UK-11913-1-26

BGCC 1<sup>st</sup> Floor Renovation

ADDENDUM #4

**Addendum Number Four**

**A2.1**

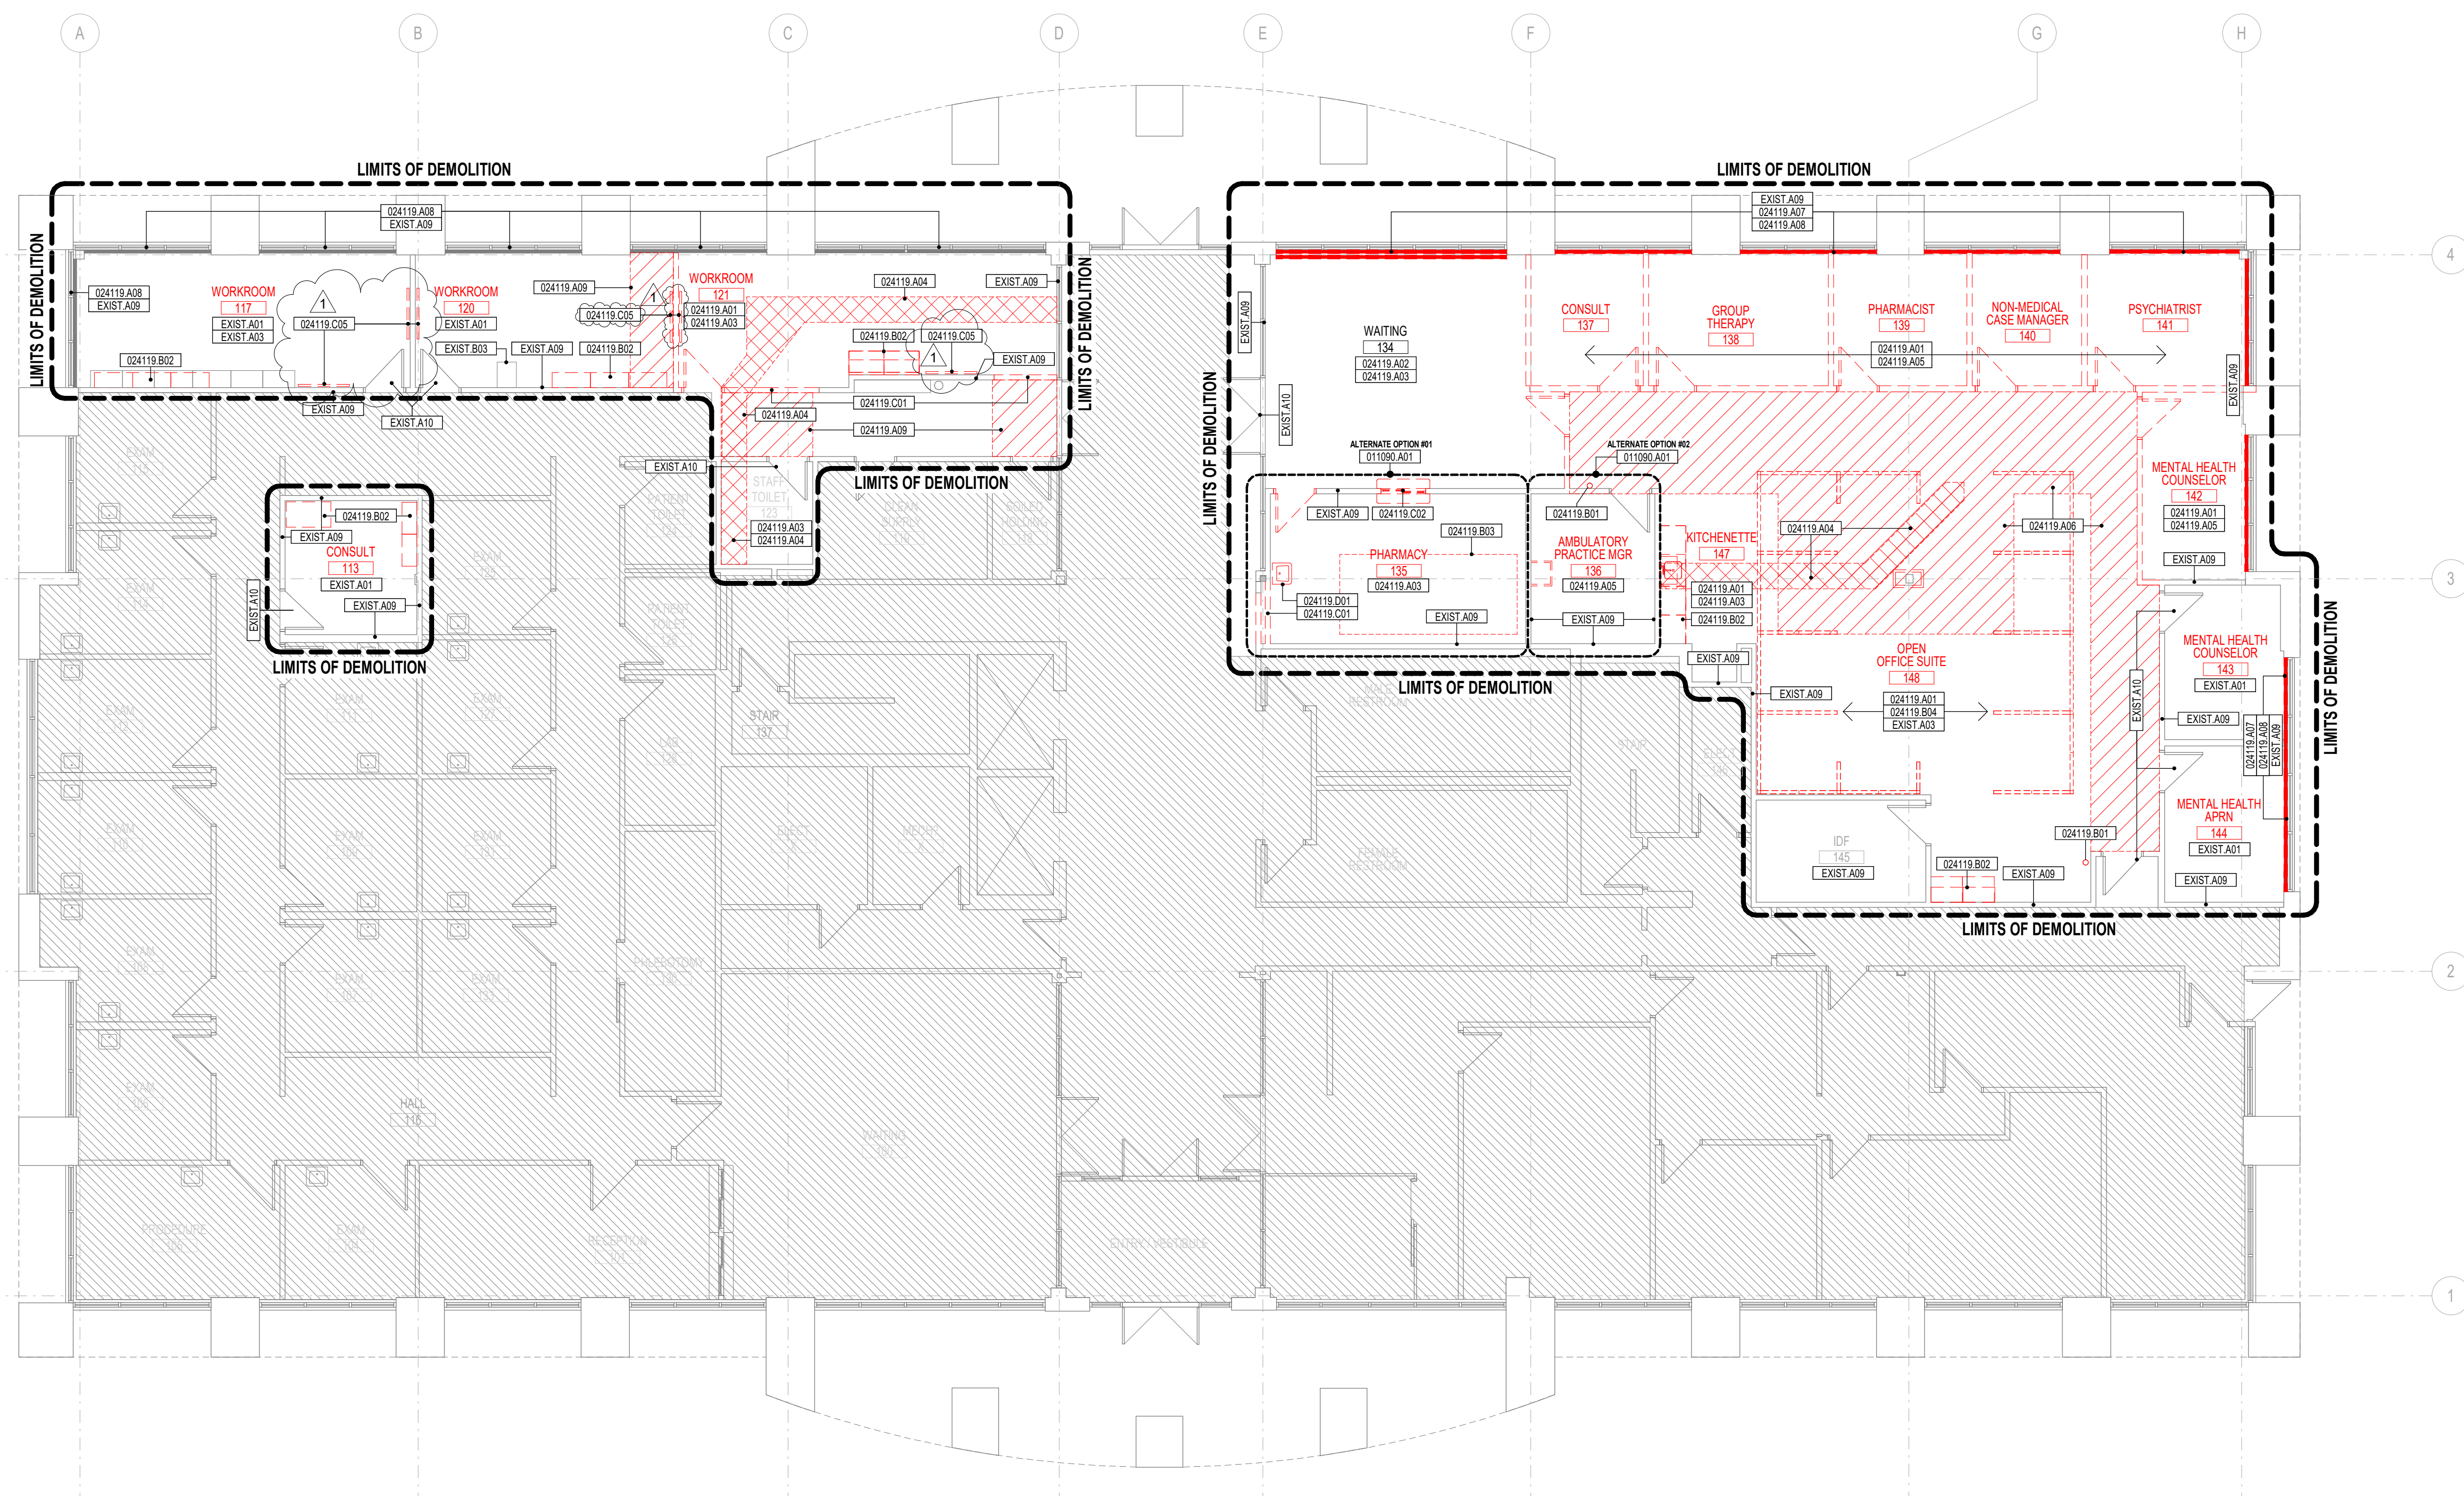
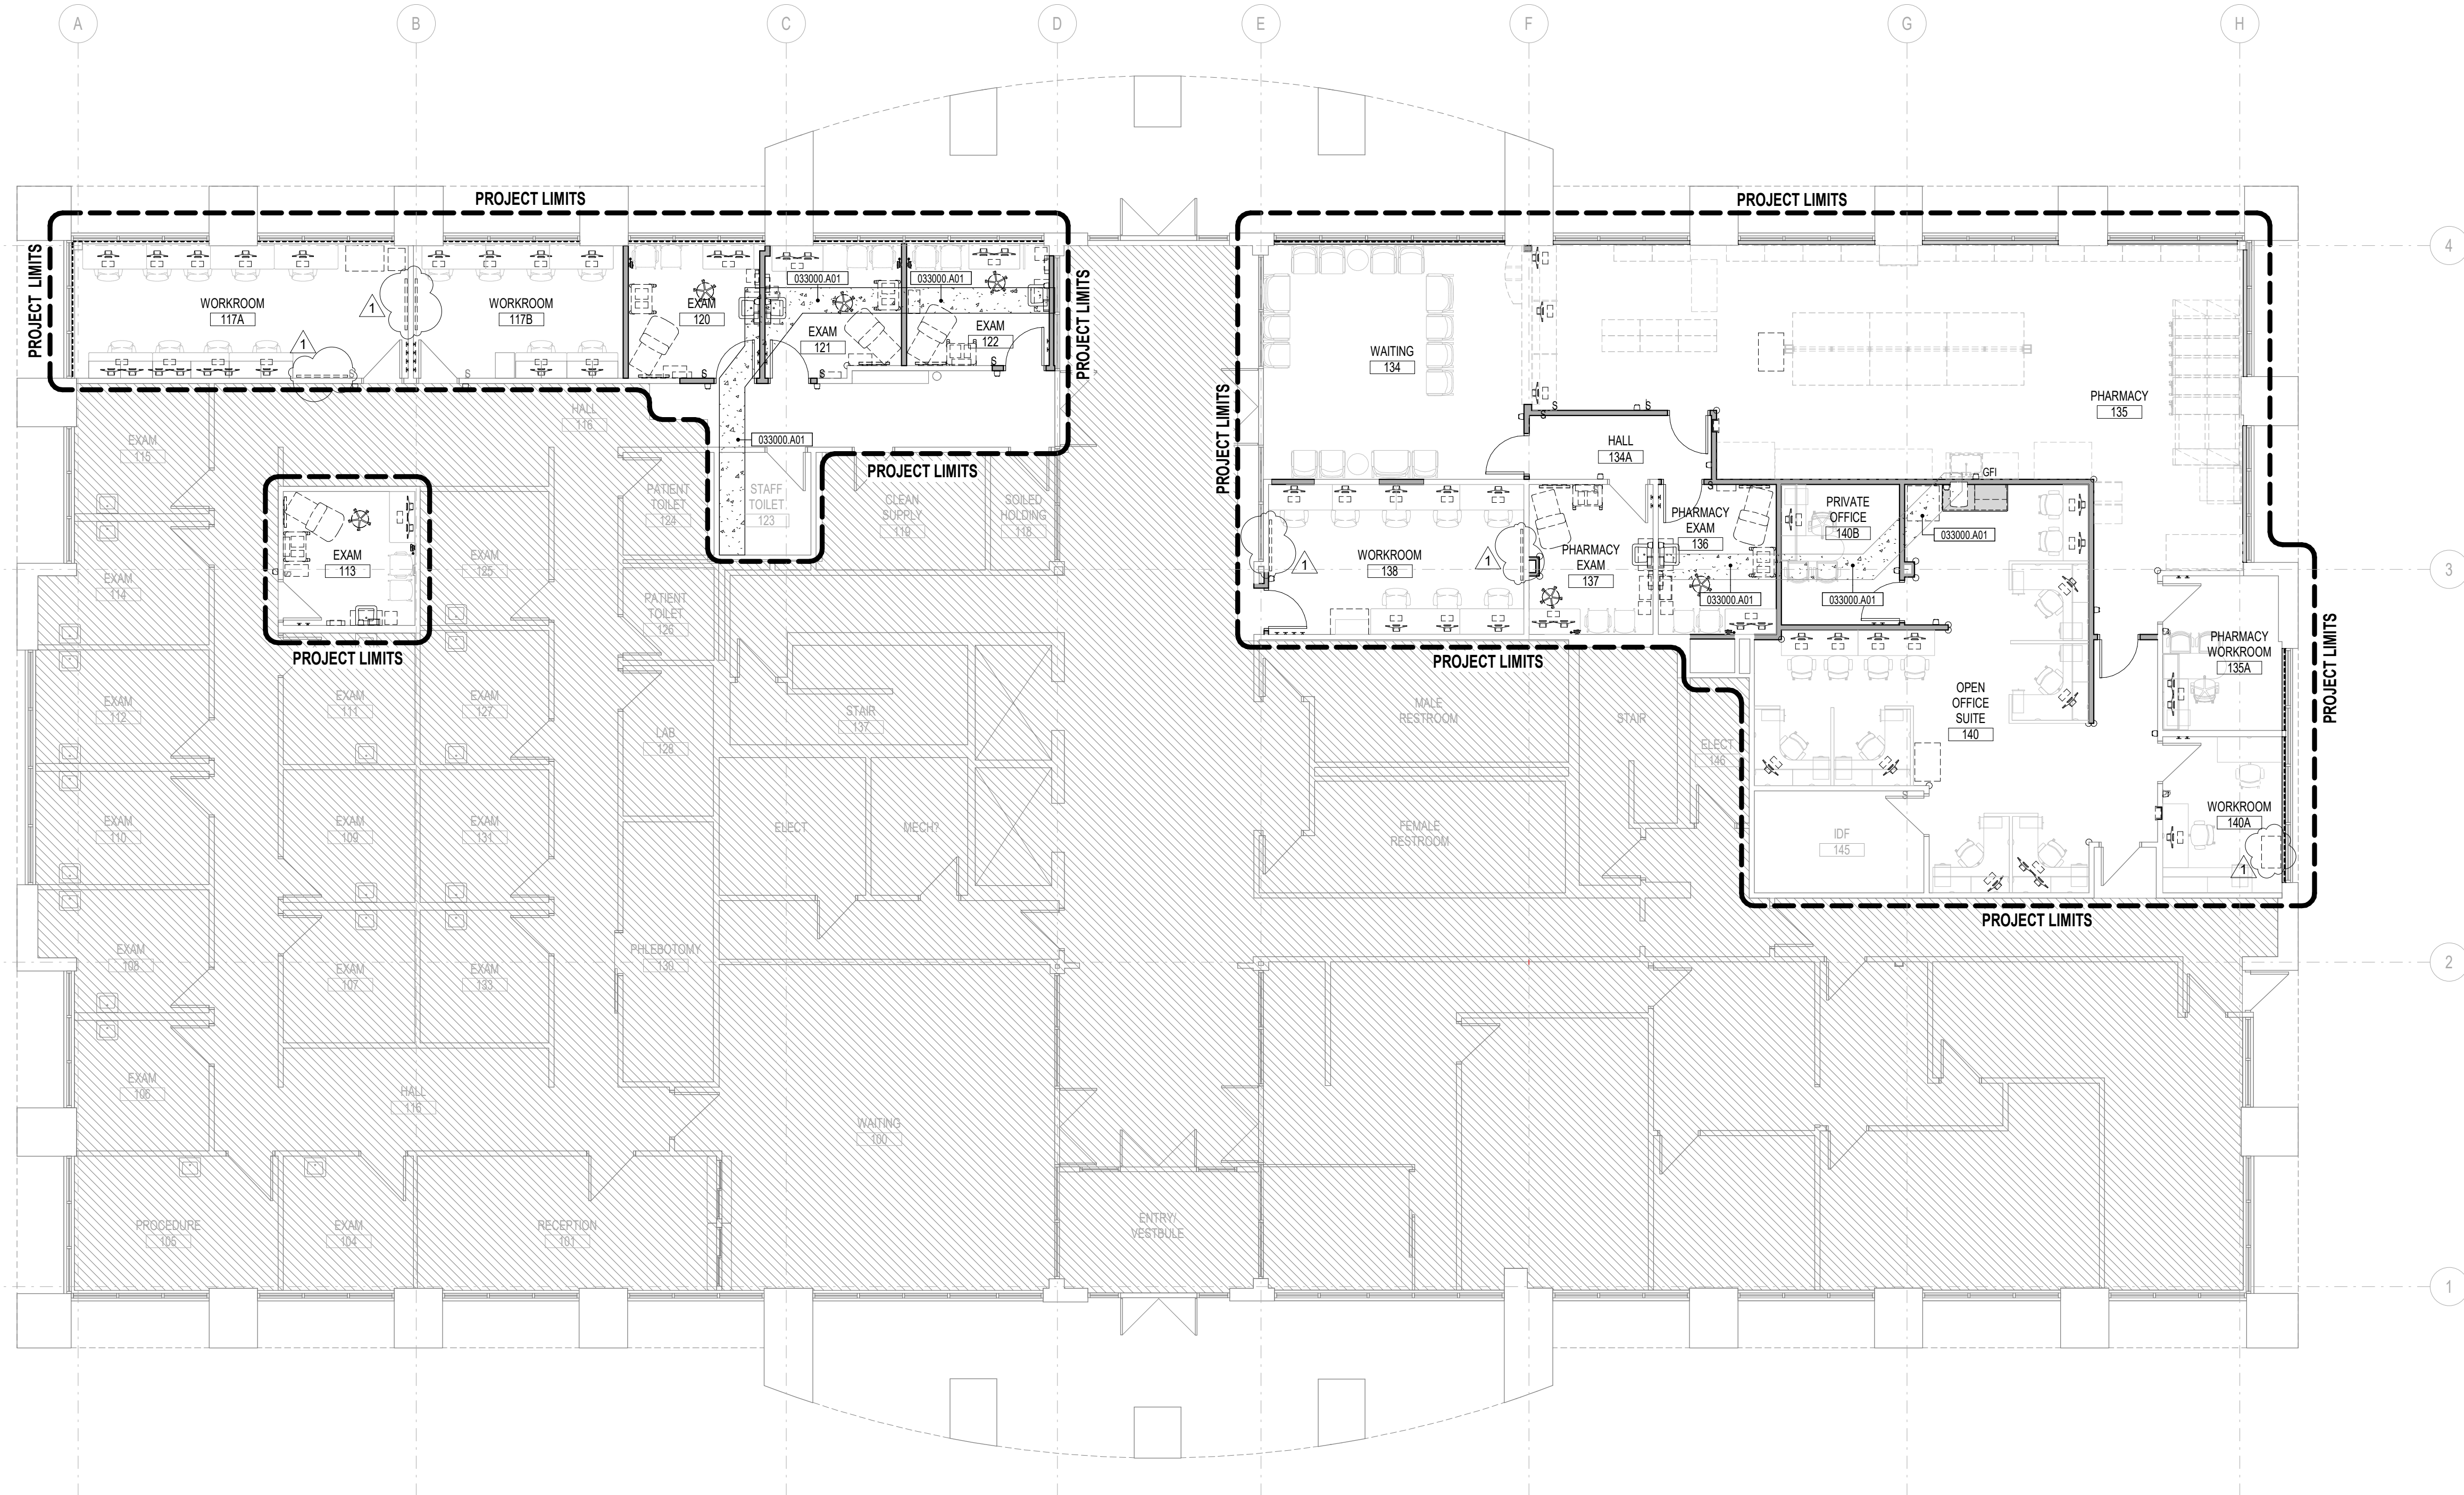
**1.03 Reference:** *A2.1 – COMPOSITE DEMOLITION PLAN*

**Clarification:** Clarified the locations of tackboard/whiteboards in response to Bidder Question #9.

**Clarification:** Added EQ-24 to Workroom 140A, previously included as part of casework.

A4.1

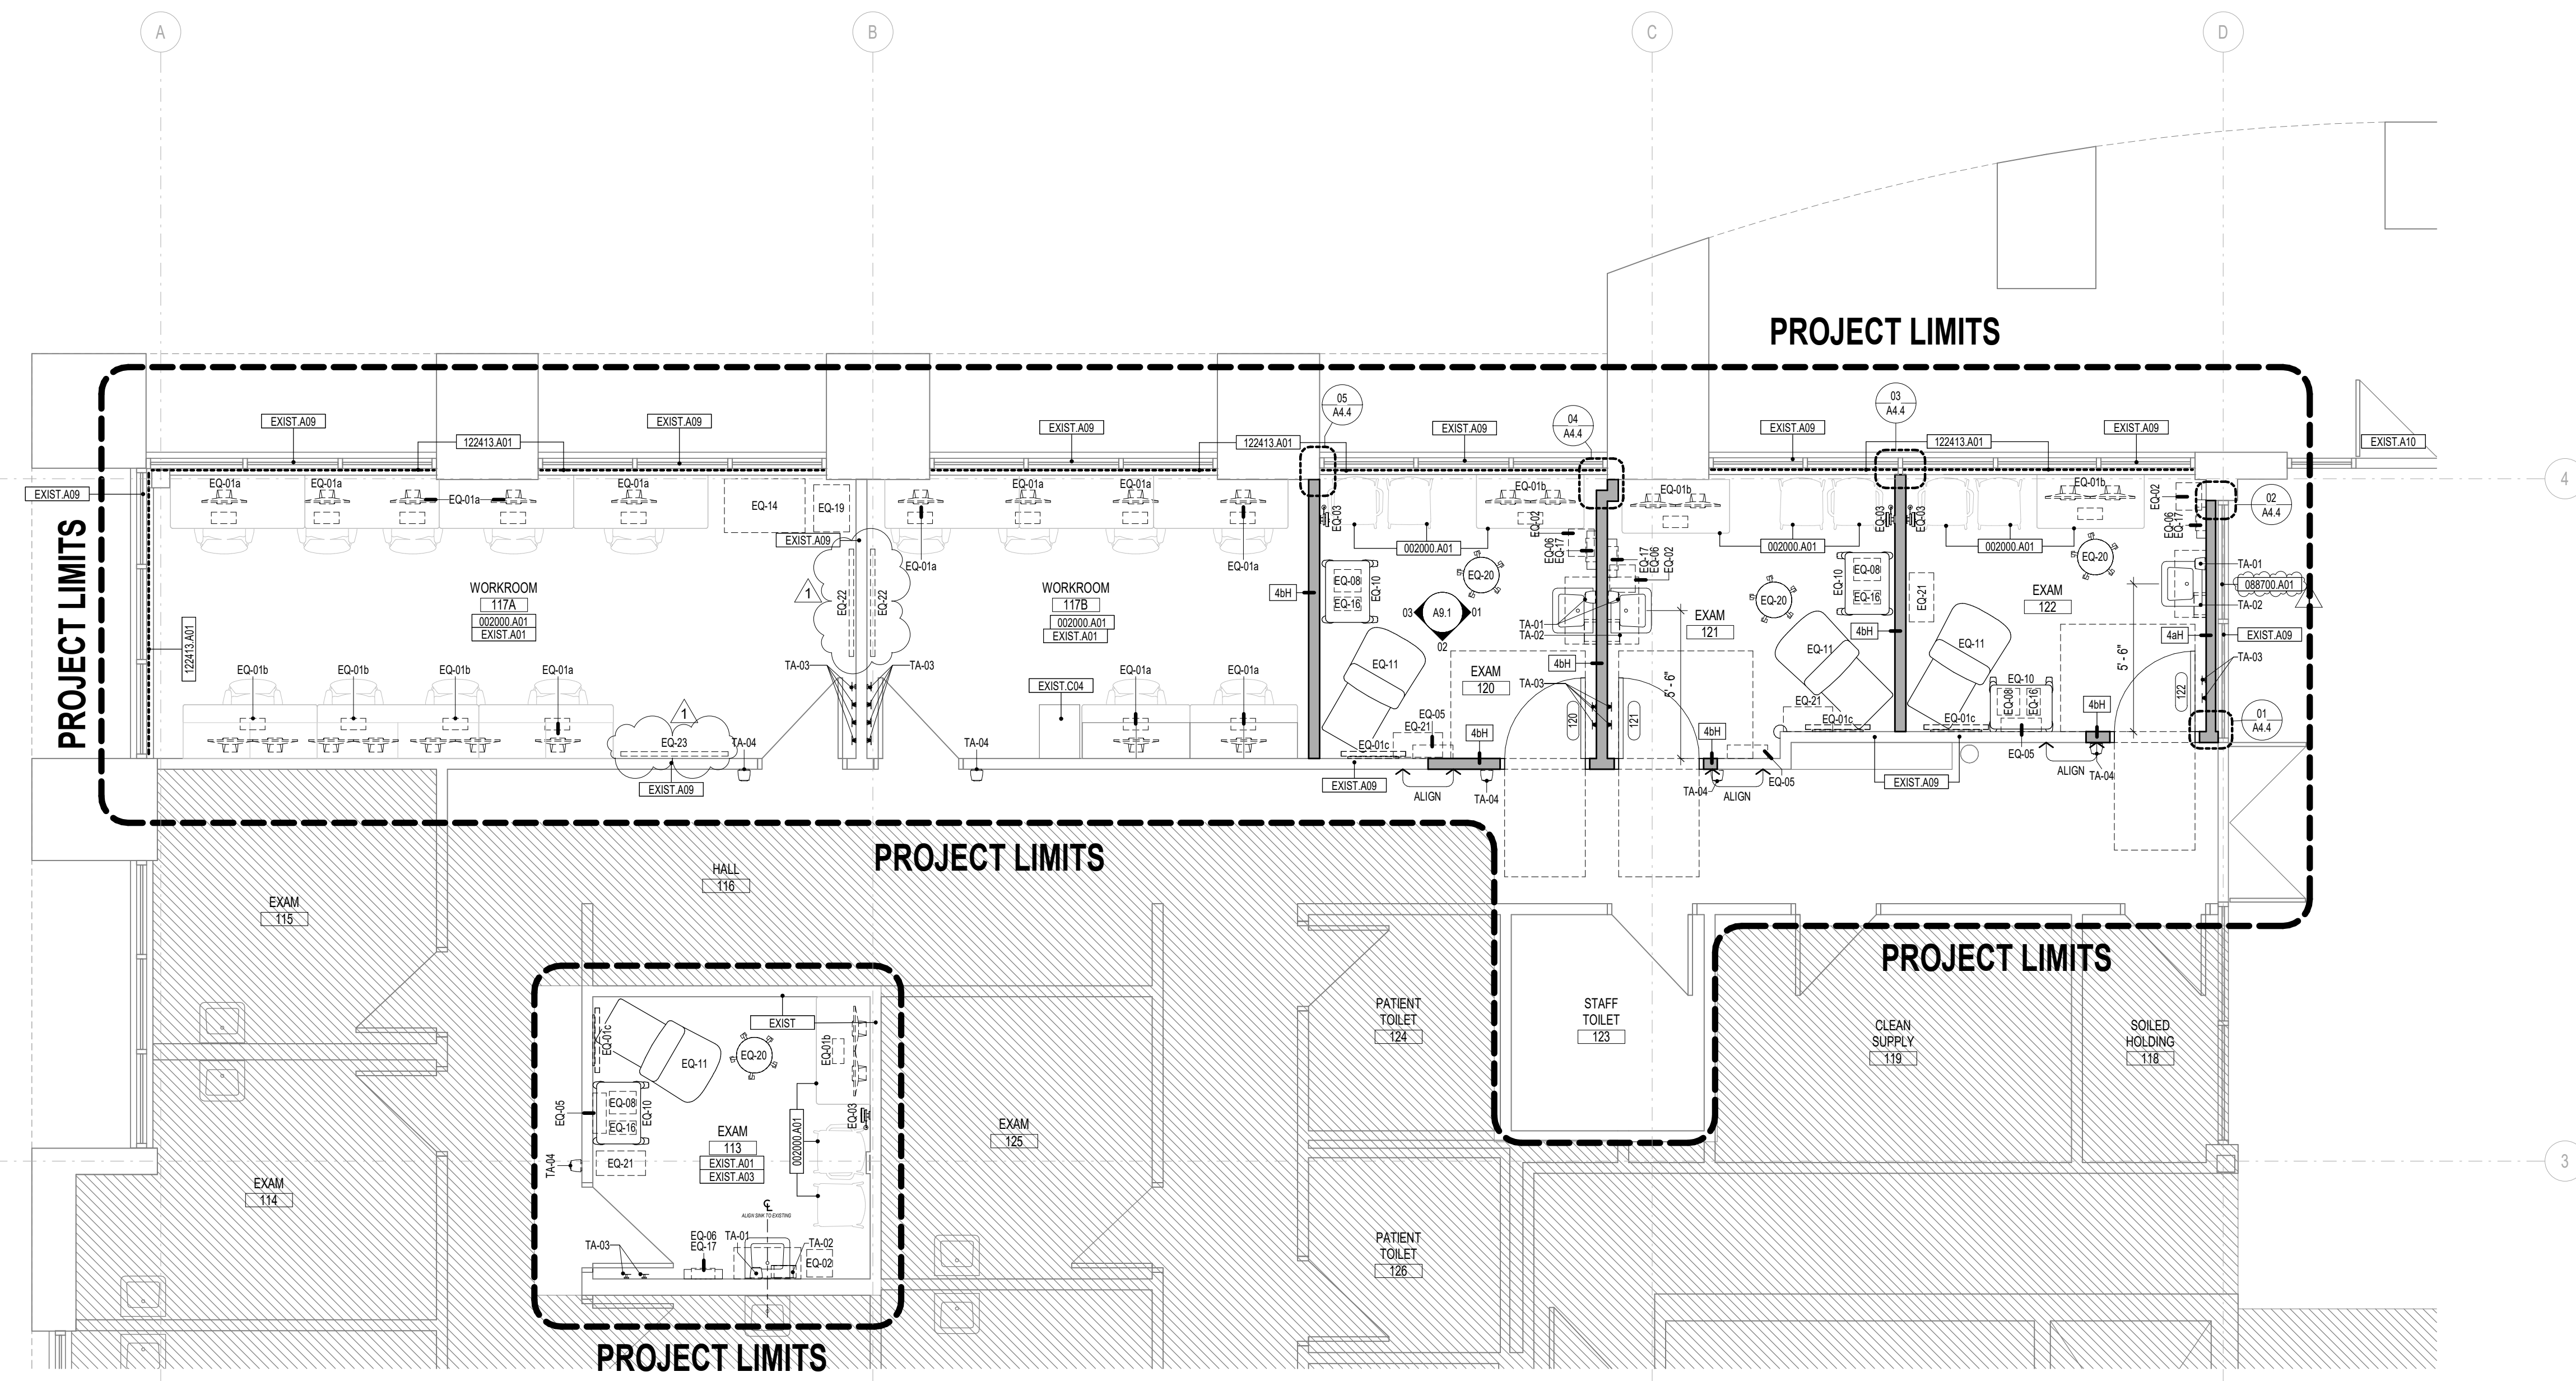
**1.04 Reference:** *A4.1 – COMPOSITE FIRST FLOOR PLAN*

**Clarification:** Clarified the locations of tackboard/whiteboards in response to Bidder Question #9.
